## Specific BCA Review

### New Indoor Basketball Stadium - 62 Hillsborough Rd Hillsborough

#### BCA requirements for Compartmentation, Services and Egress Only

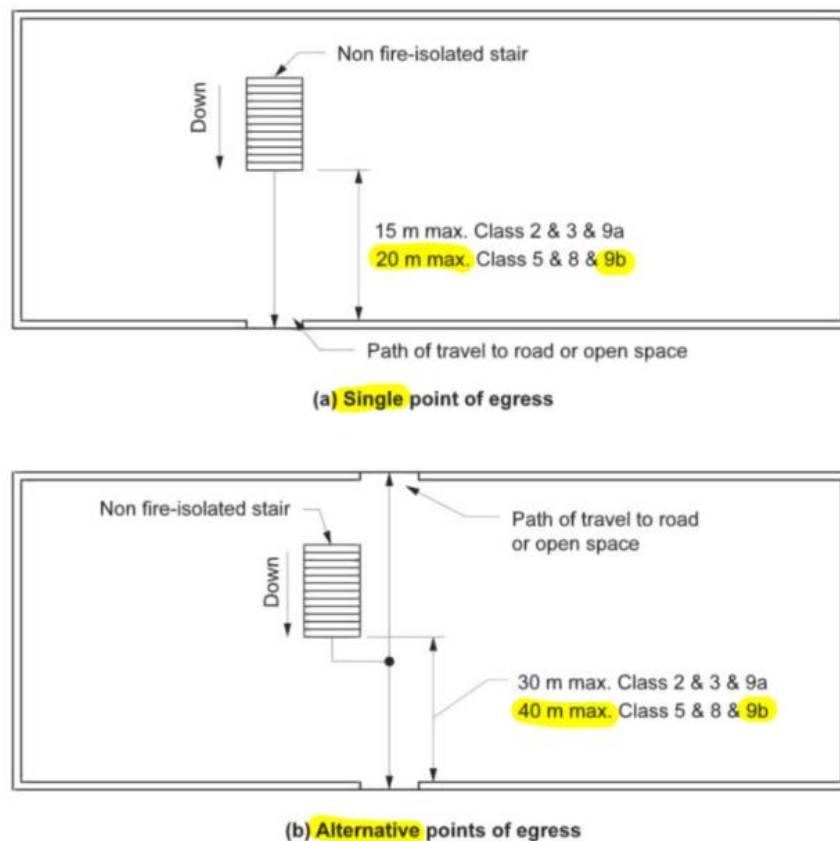
For a max expected population of 4000 this will require  $2\text{m} + ((3800/50) \times 500\text{mm}) = 40\text{m}$ . The min unobstructed aggregate exit width (path of travel to exits) shall not be less than **40m**. The will require further design development as the plans are less than this **Approx 28m currently** assuming travel distance complies, merge and pinch points are rectified. Note – all stairs that are NFI require a handrail on both sides which will reduce egress width.

BCA D1.6(f) requires the unobstructed width of a doorway used as exit shall not be less than 250mm of the required width of the exit. This will require further design development where larger population are intended to egress through front foyer.
